BIDDERS BULLETIN

PROJECT: New Auto Service & Car Wash Building
Modern Muffler Tire Pro
1402 South Jeffers
North Platte Nebraska

BB-1

DATE ISSUED: April 23, 2012

WashSoft Traffic-Management Site Layout Overview

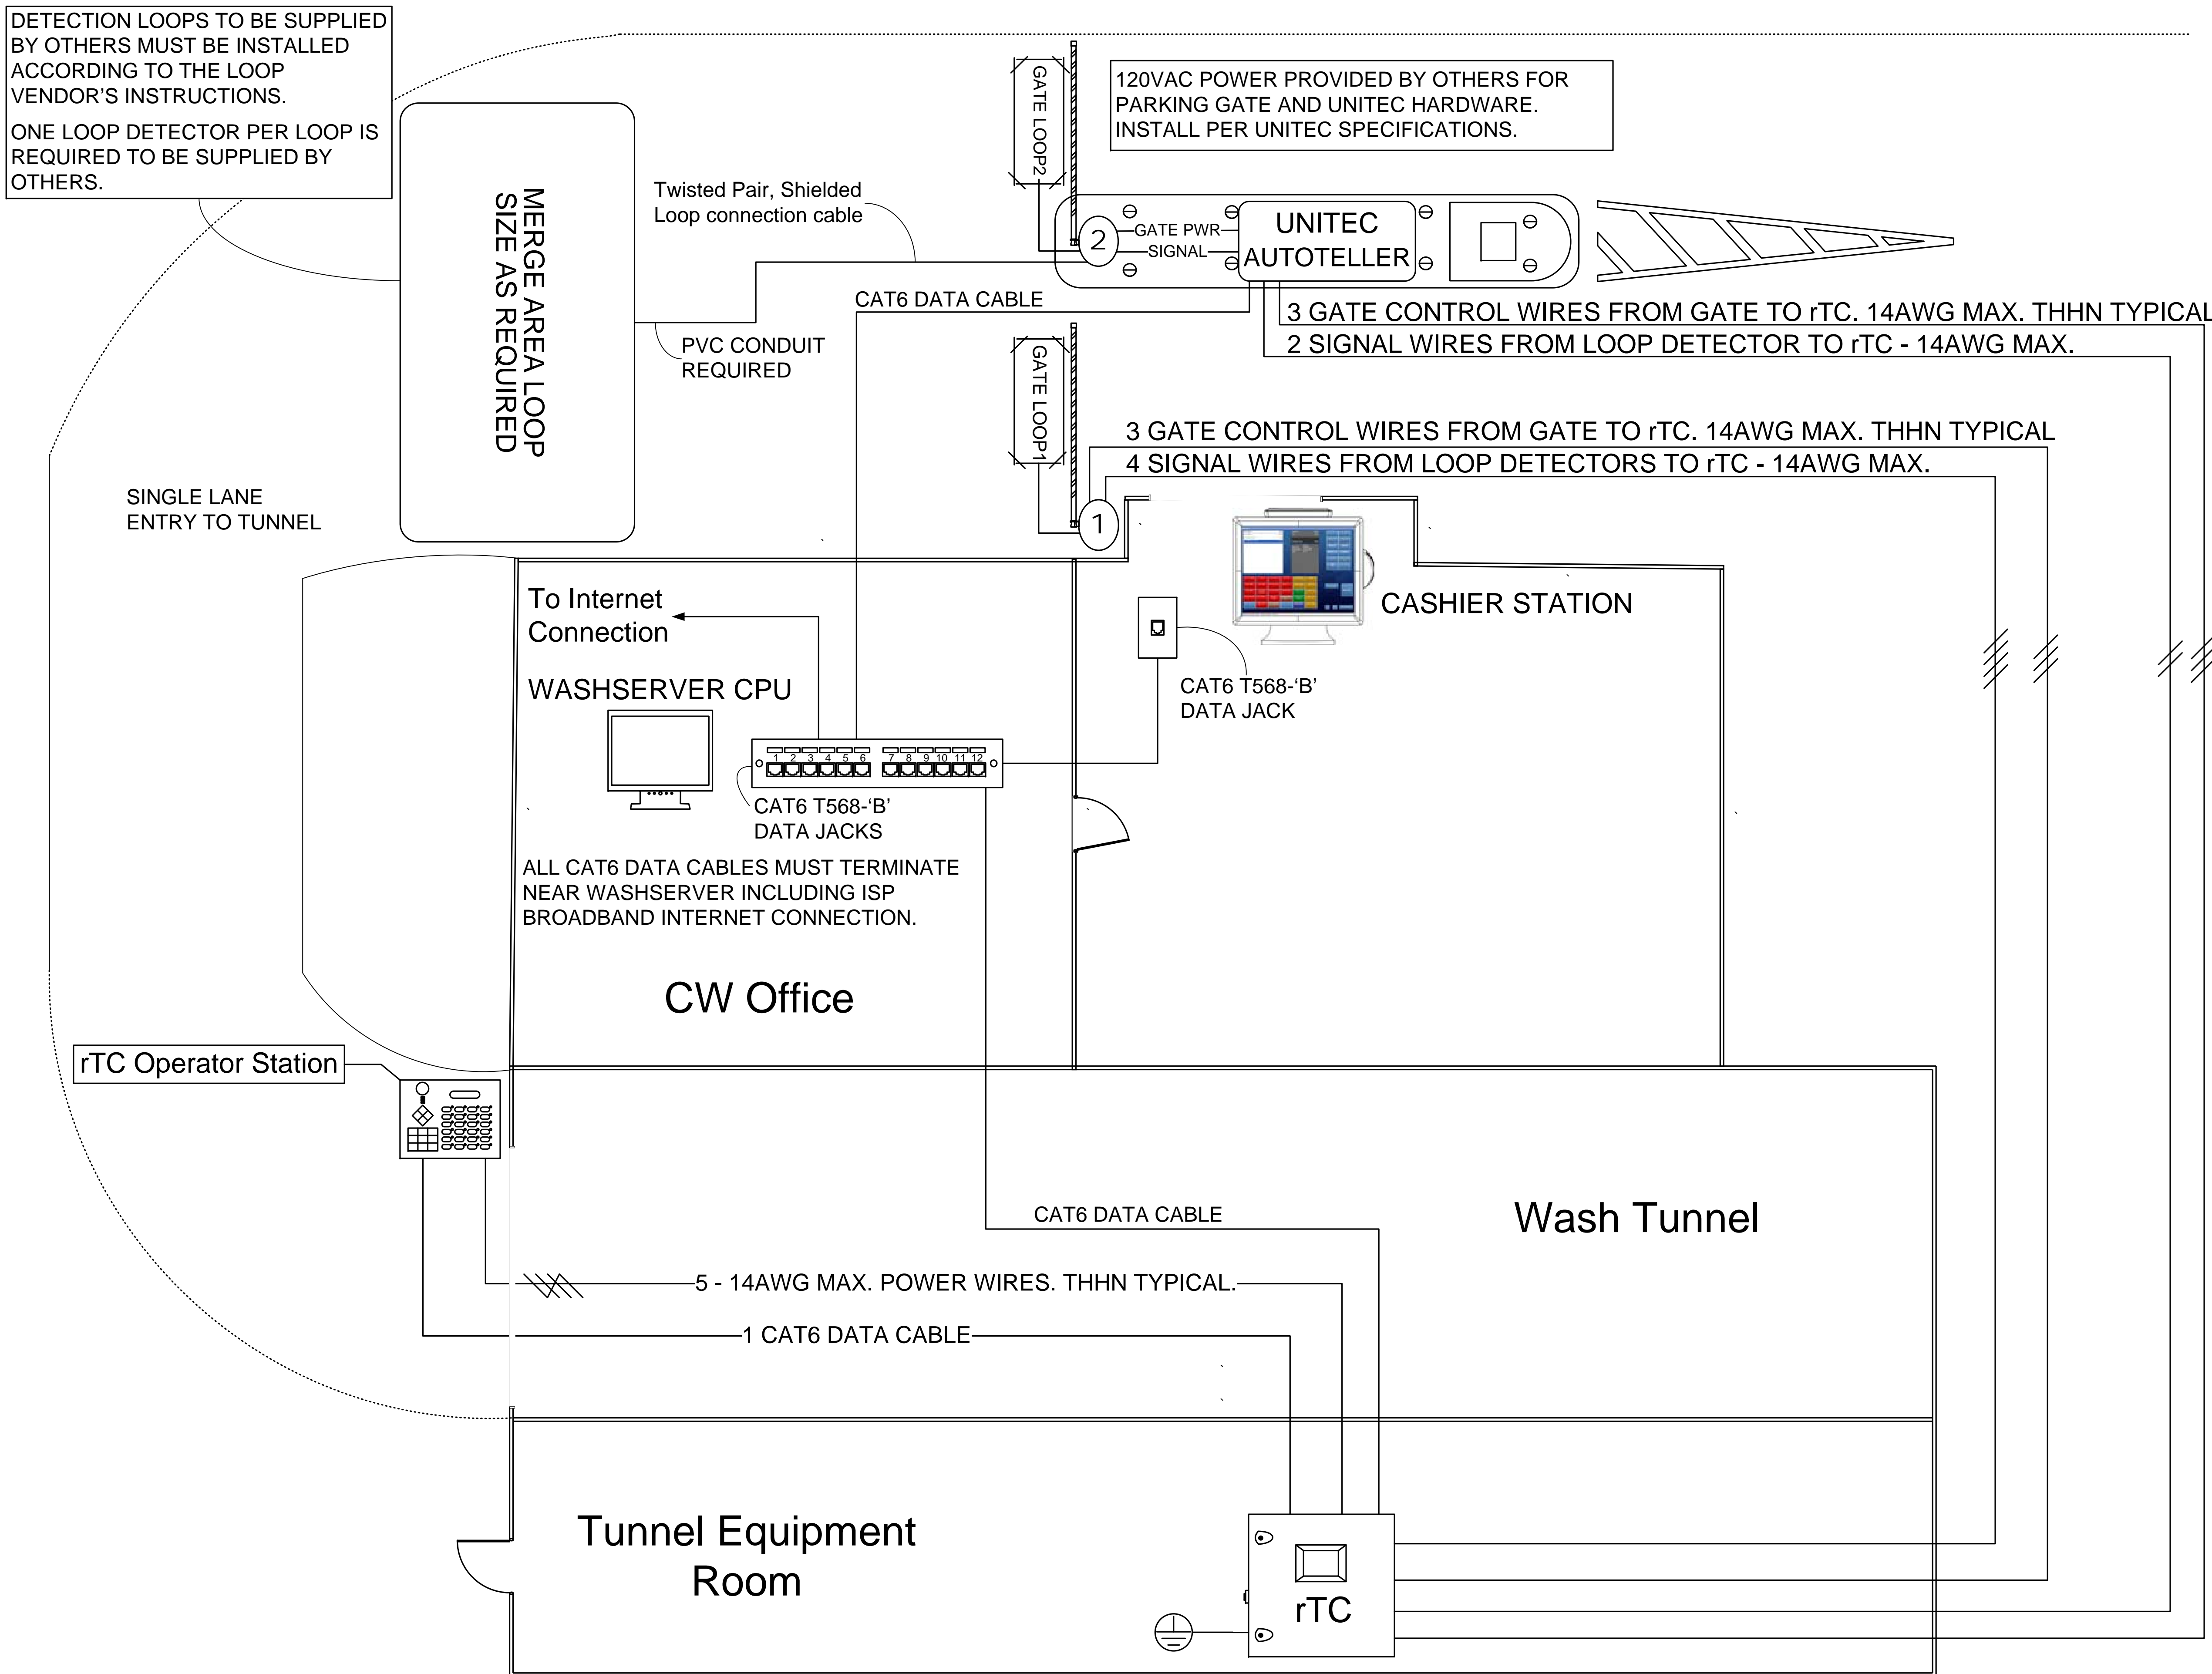
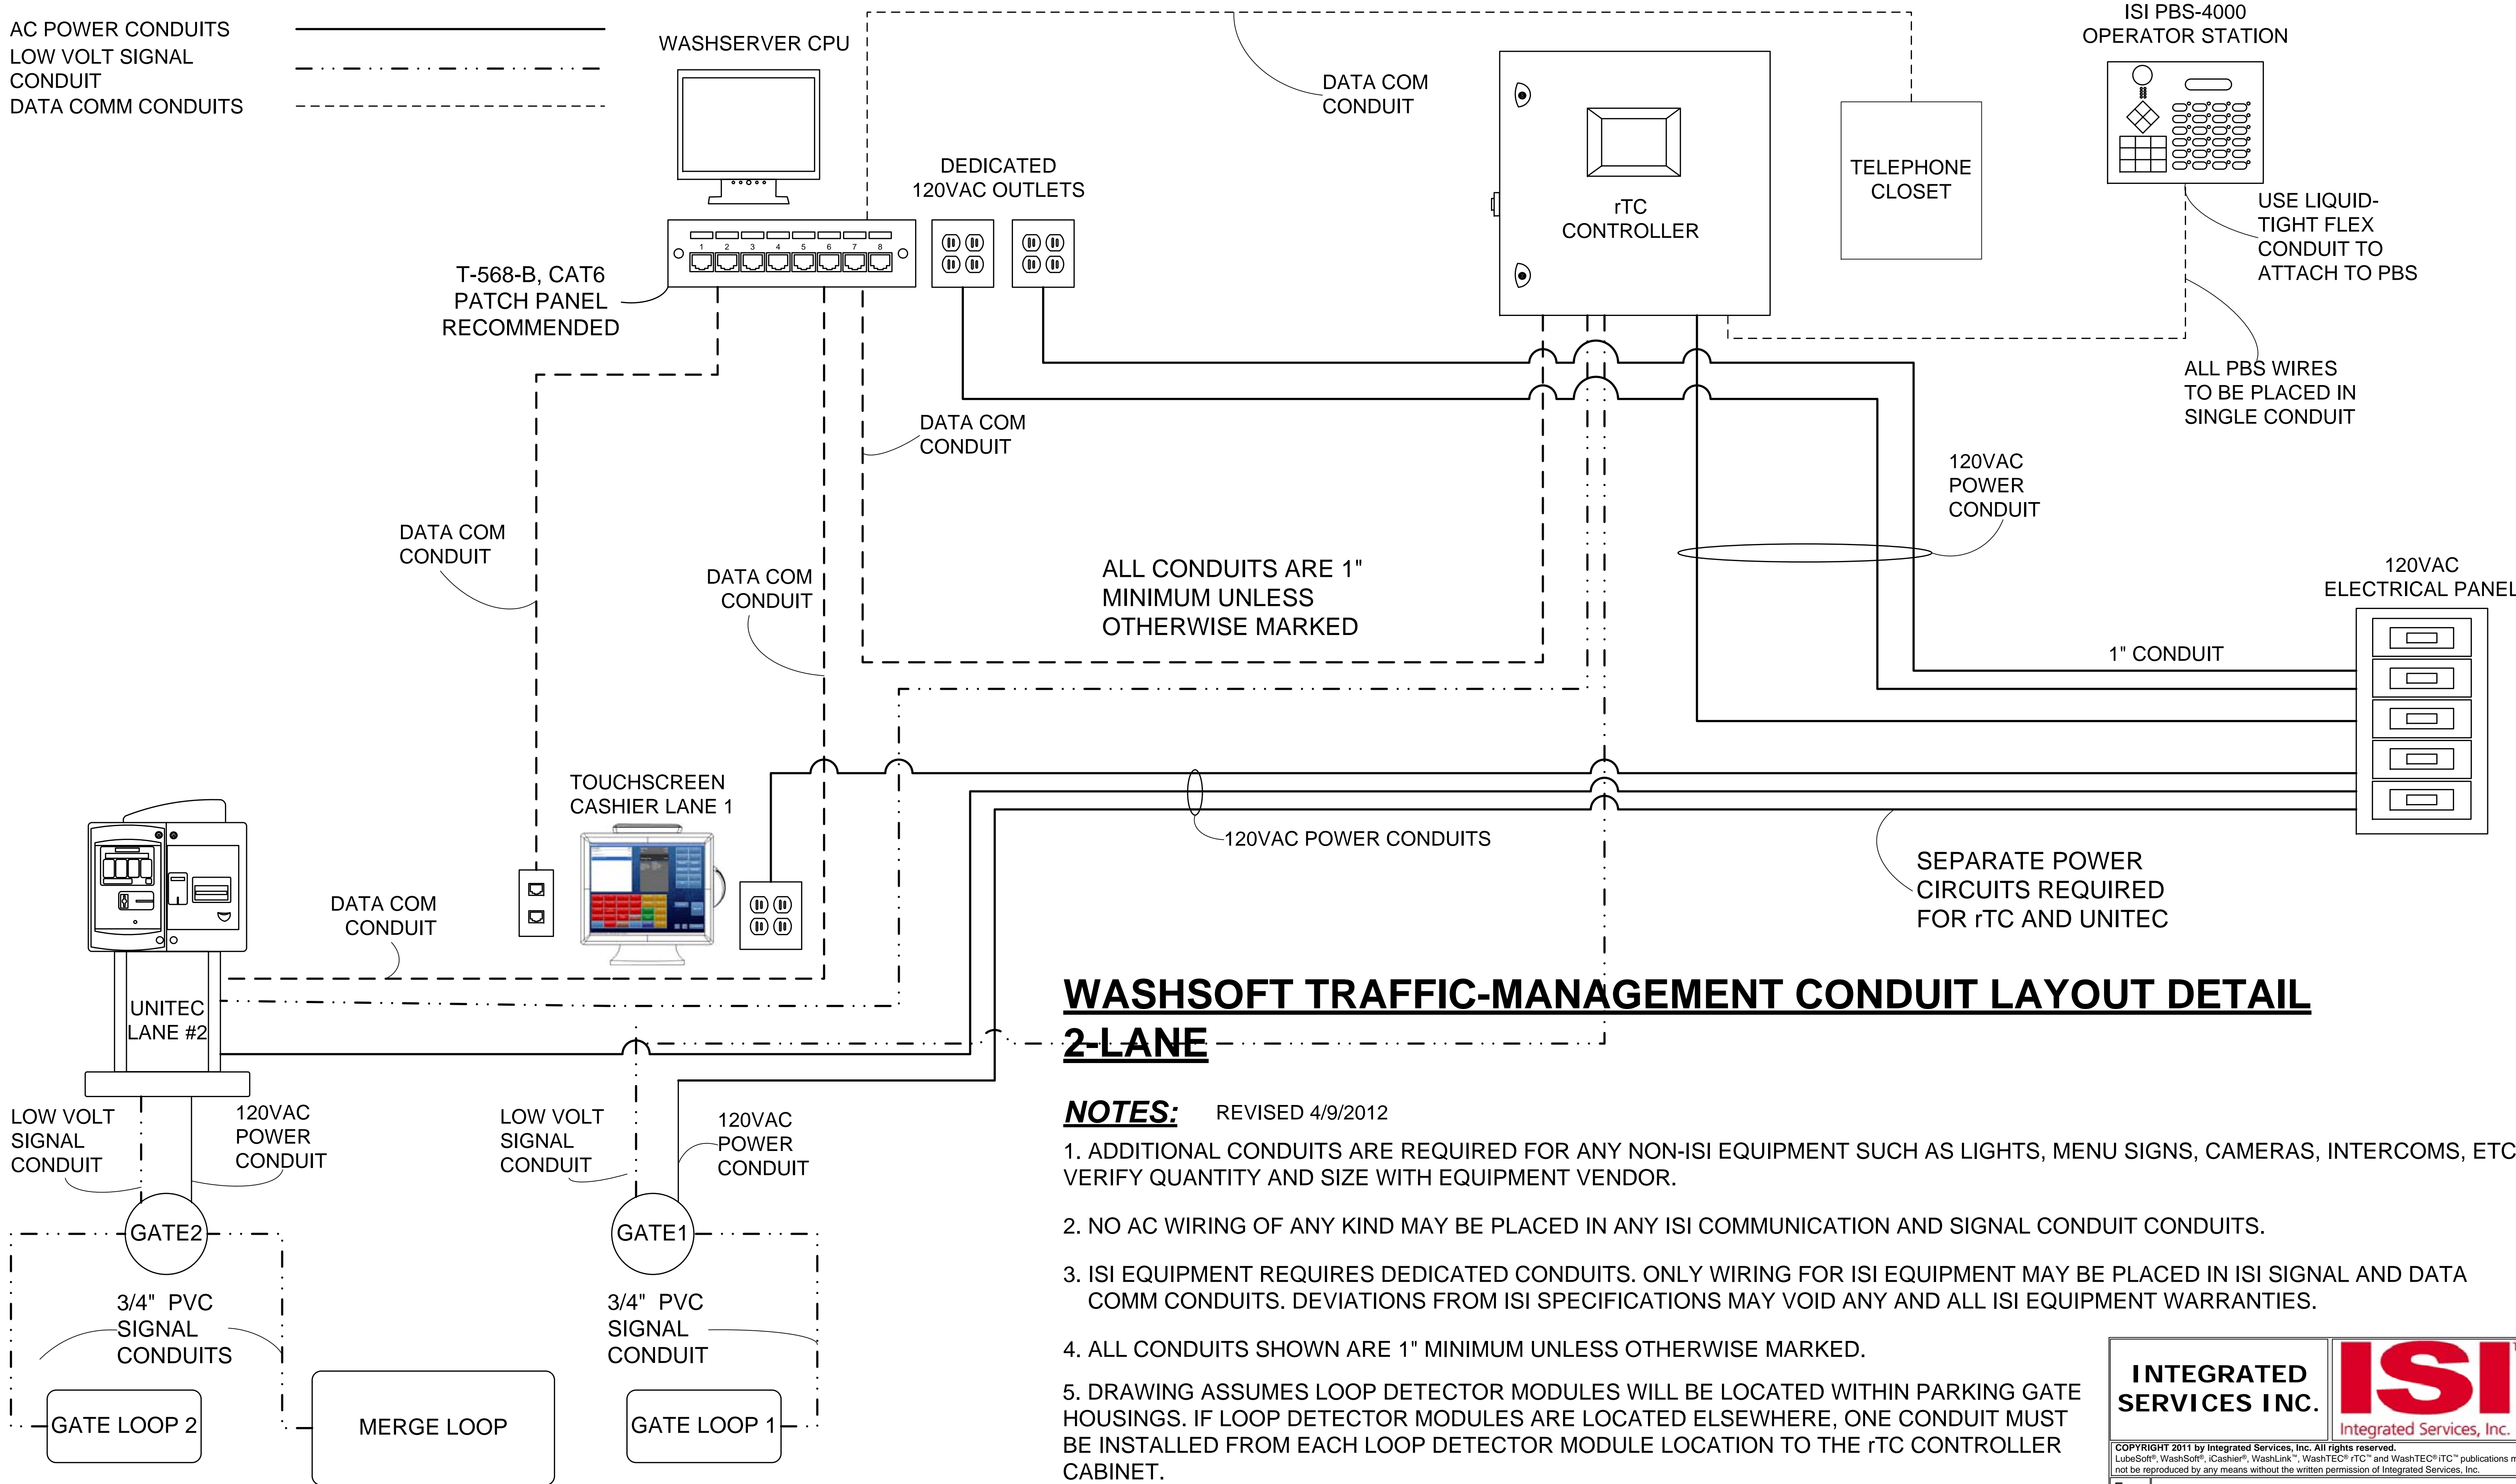
Item #13: E201 – Traffic Management System: Provide conduits and control wiring for traffic management system furnished by Integrated Services Inc. (ISI) as called out on Traffic Management drawings included in this addendum. Coordinate exact requirements with owner and supplier.
